Architectural Review Board Staff Report
July 13, 2026 Meeting

**6905 CENTRAL COLLEGE ROAD NEW HOME
CERTIFICATE OF APPROPRIATENESS AND WAIVERS**

LOCATION: 6905 Central College Road (PID: 222-000349)
APPLICANT: Old World Custom Homes c/o Patrick Miller
REQUEST: Certificate of Appropriateness with waivers
ZONING: Residential Estate District (R-1)
STRATEGIC PLAN: Residential
APPLICATION: ARB-36-2026

This application was originally reviewed by the Architectural Review Board at its meeting on June 8, 2026. Multiple updates to the application have been made to better conform to the DGRs and to respond to the comments and concerns made by the Board and city architect. Changes to this staff report from the original application have been underlined. Overall, the main changes to the application include:

FRONT ELEVATION
SCALE: 3/16" = 1'-0"

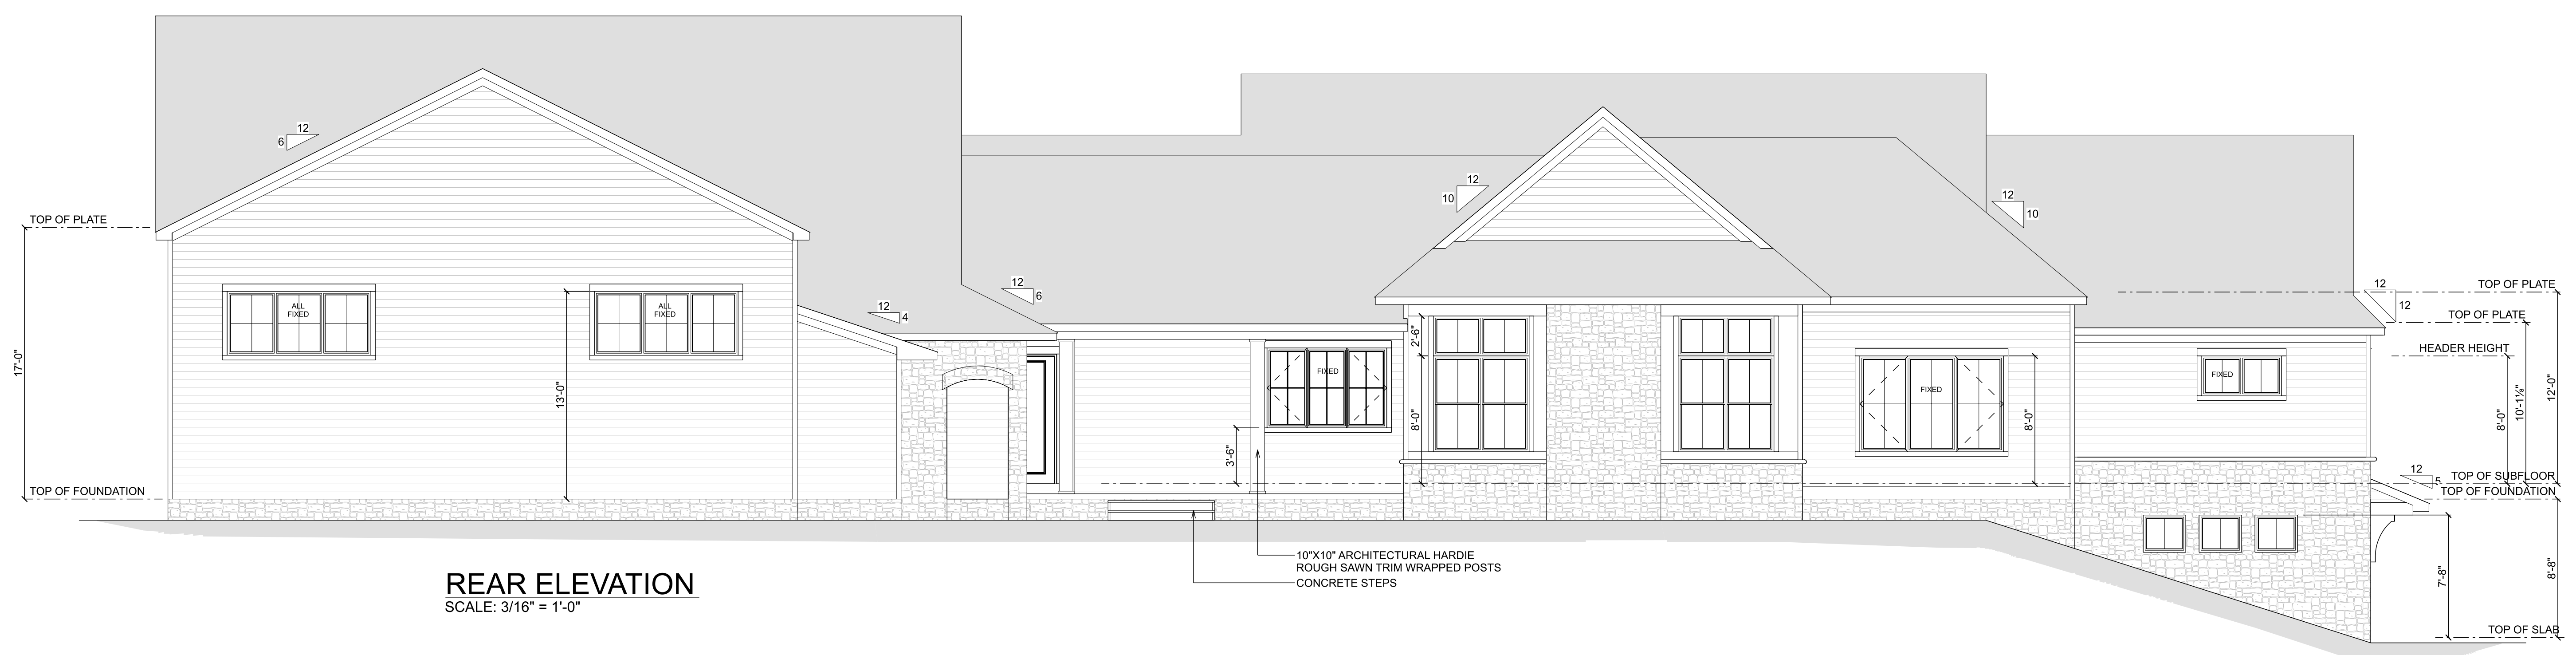
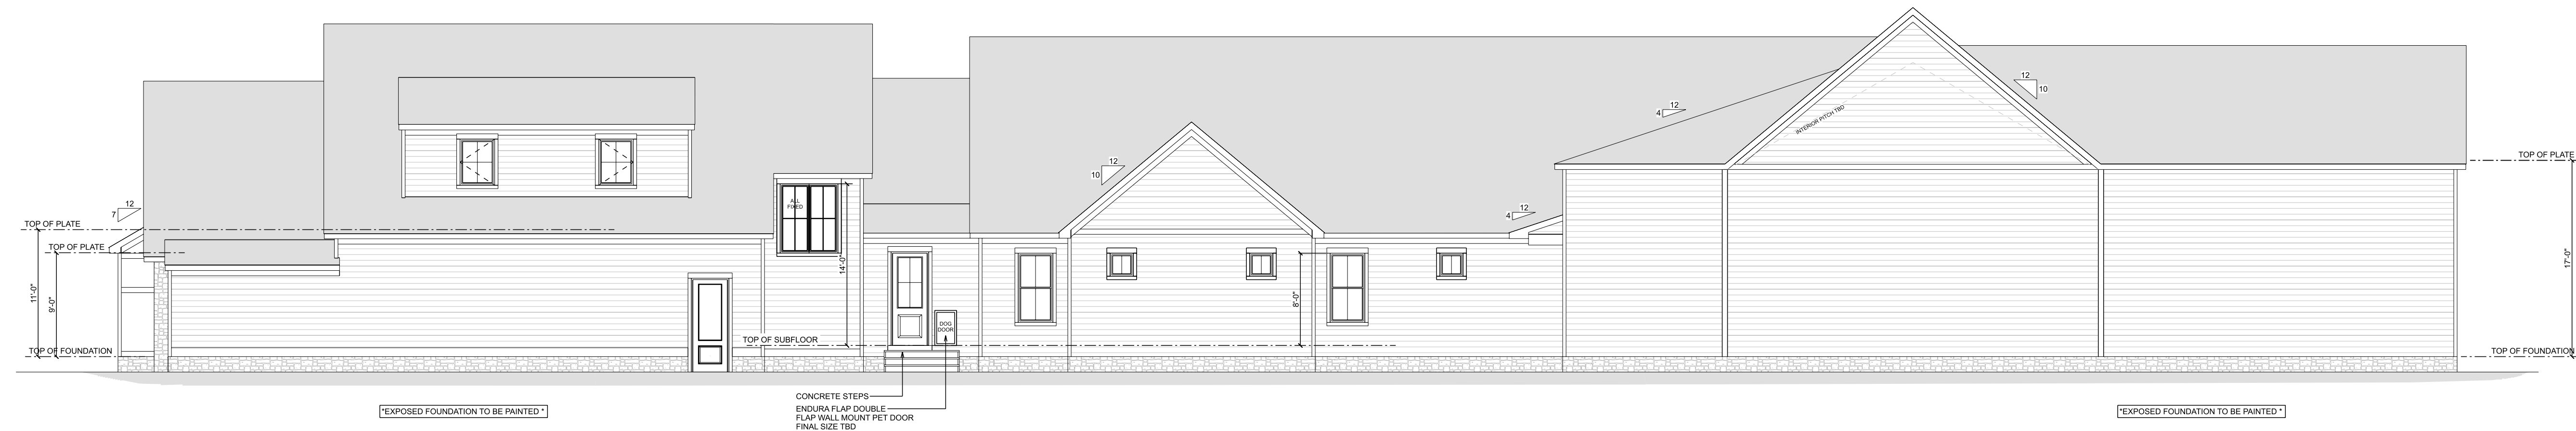
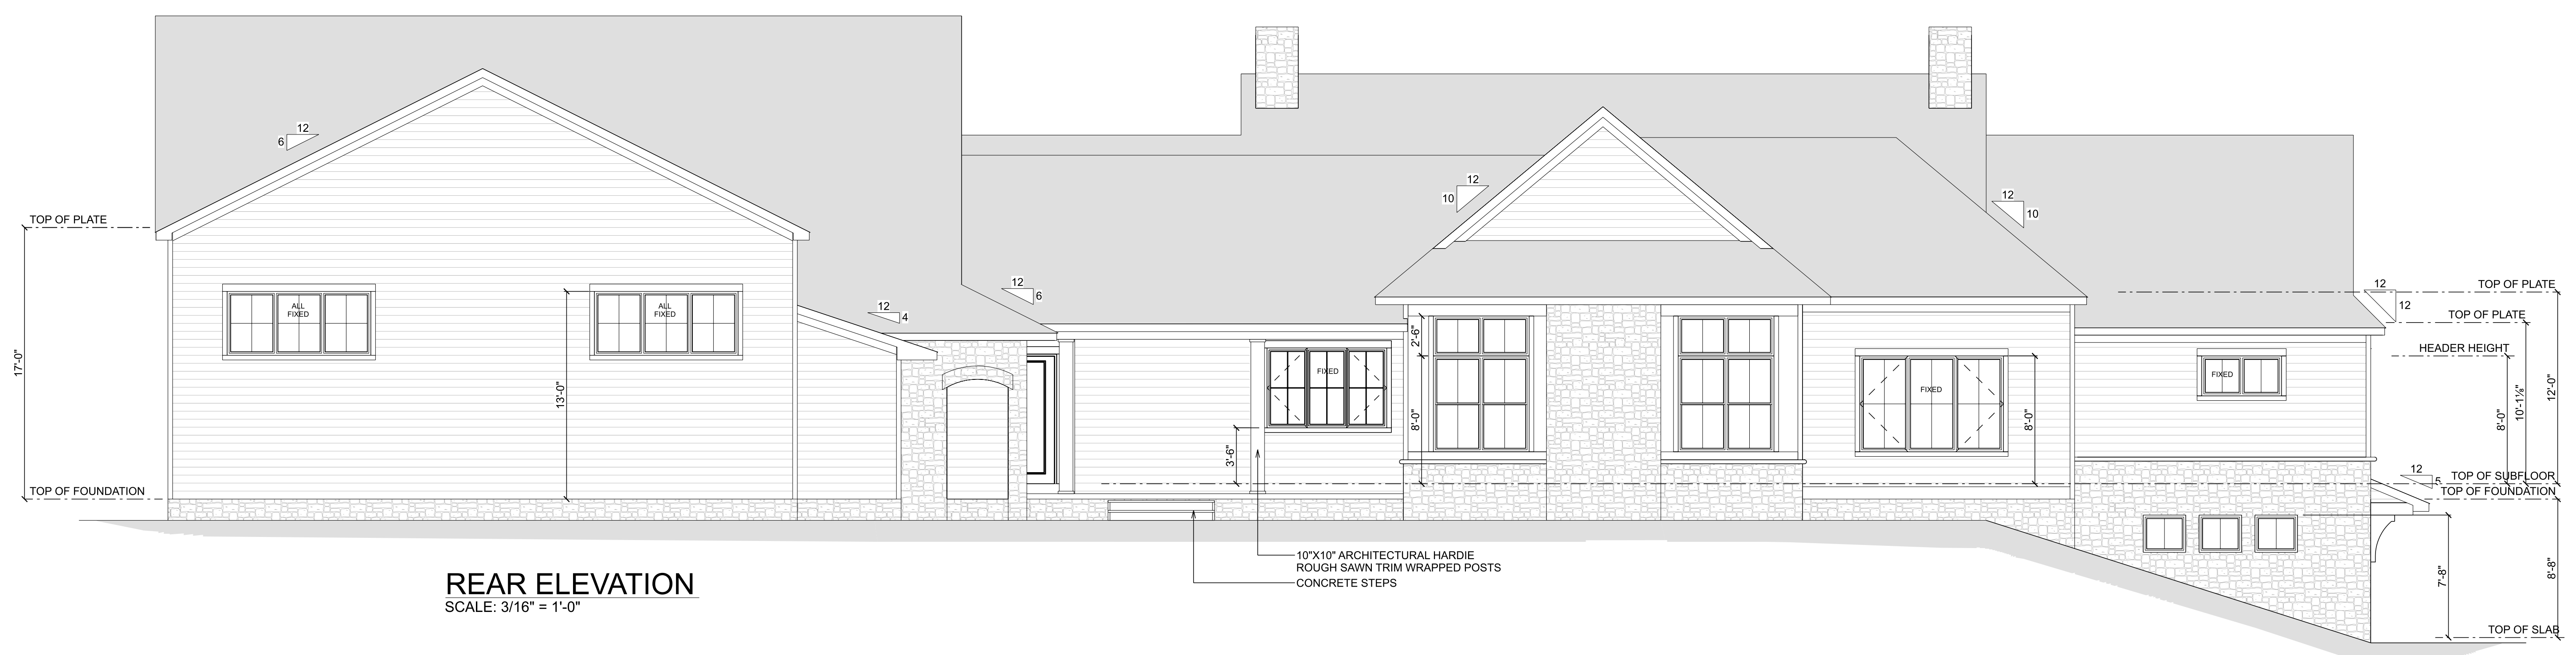
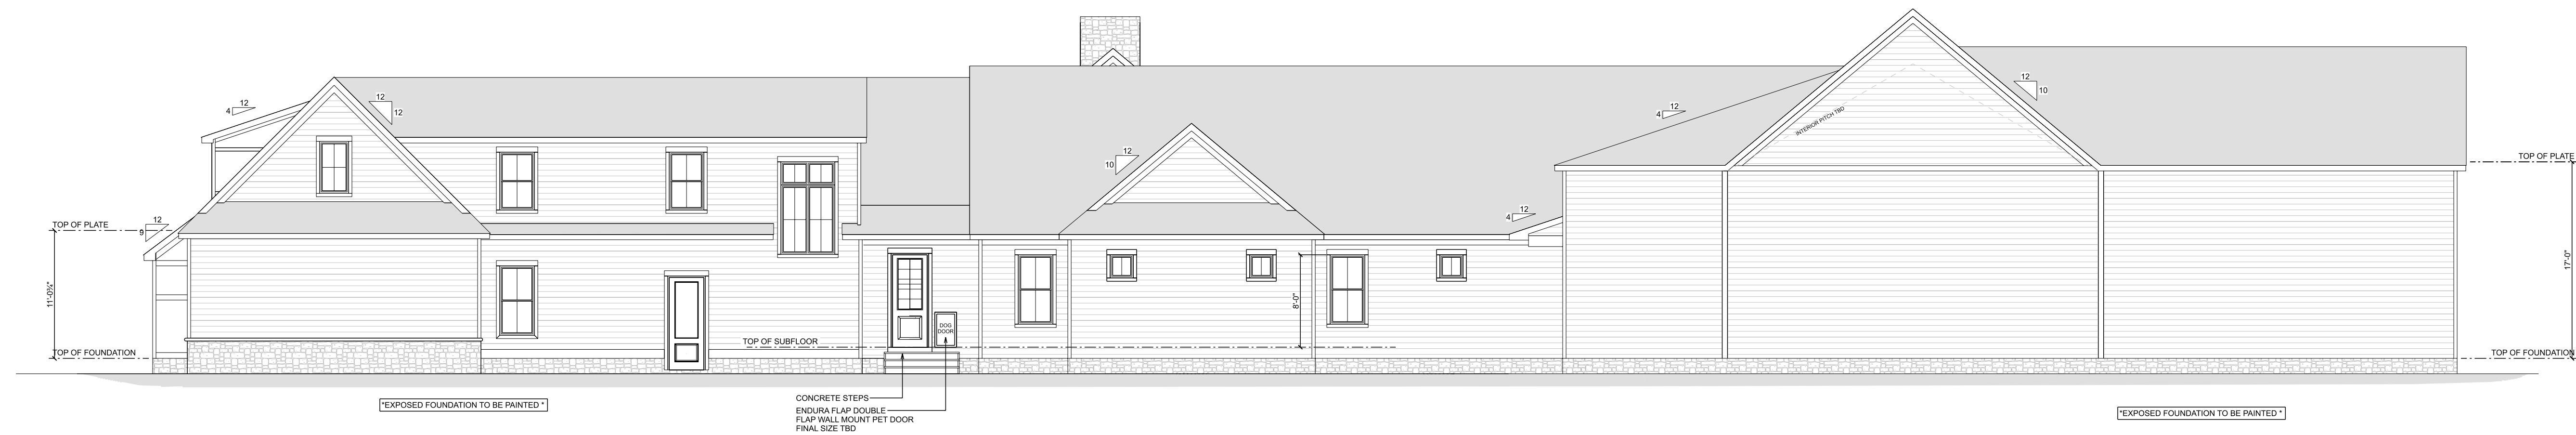
- The city architect is highly supportive of the updates to the plans. Most of the updates apply to the garage portion of the home, which the city architect and Architectural Review Board found to be large, bulky, and architecturally unrelated to the main house form and appeared to dominate the rest of the building. The city architect states that he believes the new composition is the correct approach, as it allows the garage to be a cohesive part of the architectural strategy.

- The applicant has added a turned gable at the end of the garage, running in the same direction as the main house mass. The new gable allows the overall garage mass to be reduced while “breaking up” the formerly long façade into elements with a more human scale. This gable allows the garage to appear more comparable and cohesive with the main house mass.

- Windows have been added to the frontmost façade on the garage, facing the public right-of-way. As supported by the DGRs, the windows give this portion of the house the appearance of being “lived in;” the garage mass feels more human-scaled and as an active part of the rest of the house.

Image: Before (top) and after (bottom), showing the changes made to the house design. The garage gable has been rotated and the form has been adjusted to create a stronger sense of cohesion with the main portion of the home.

LEFT ELEVATION
SCALE: 1/8" = 1'-0"

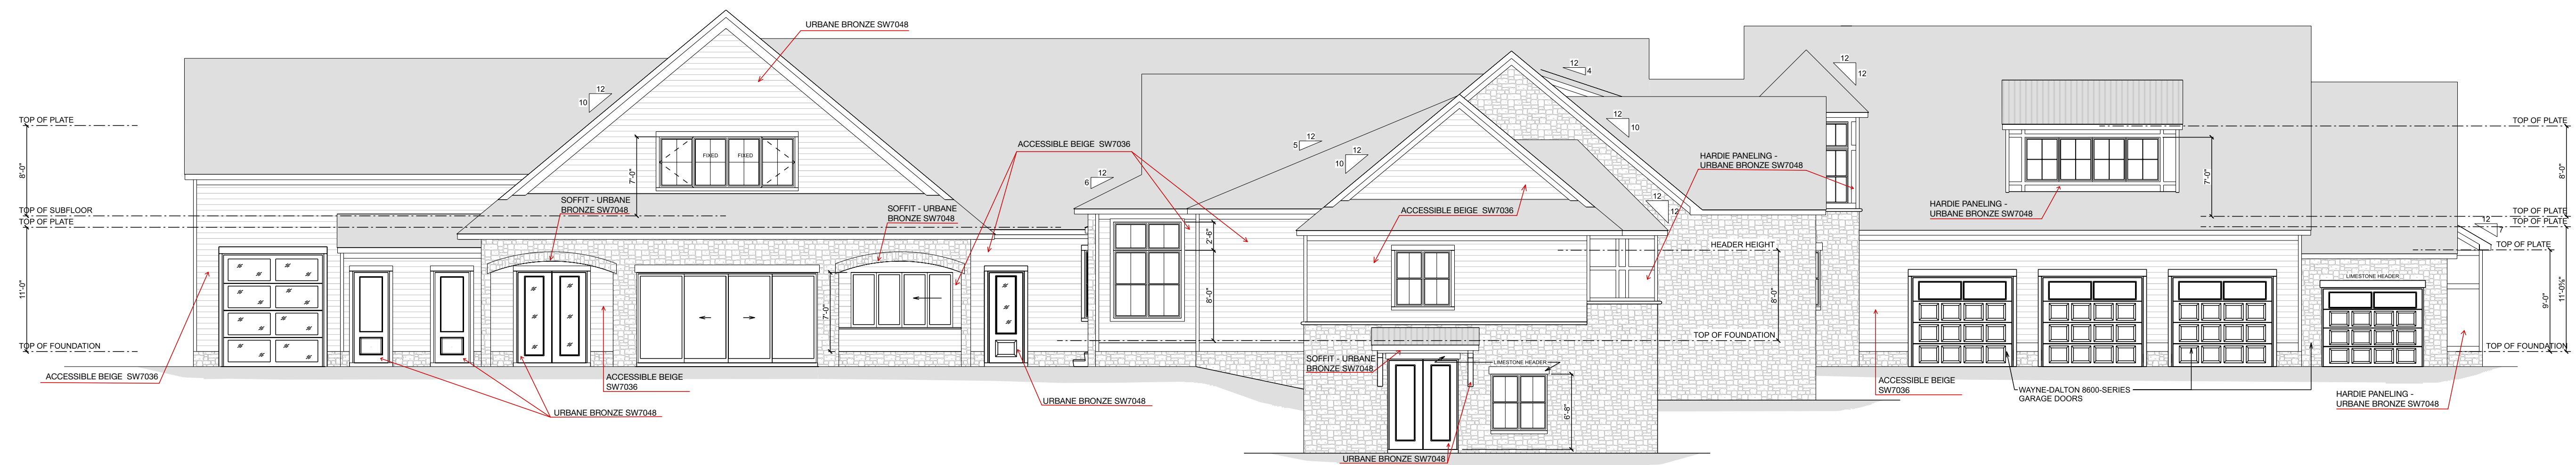
- The left elevation of the garage mass has been divided between the area with the new gable form and a newly inset “connector” between the main house and new gable. The applicant also proposes one double-bay garage door on the “connector” part of the façade (see waiver C), which further breaks up the former repetition and visual dominance of the full elevation. Additionally, there is a single shed roof dormer centered above the double-wide garage door, which helps ground the architectural strategy.
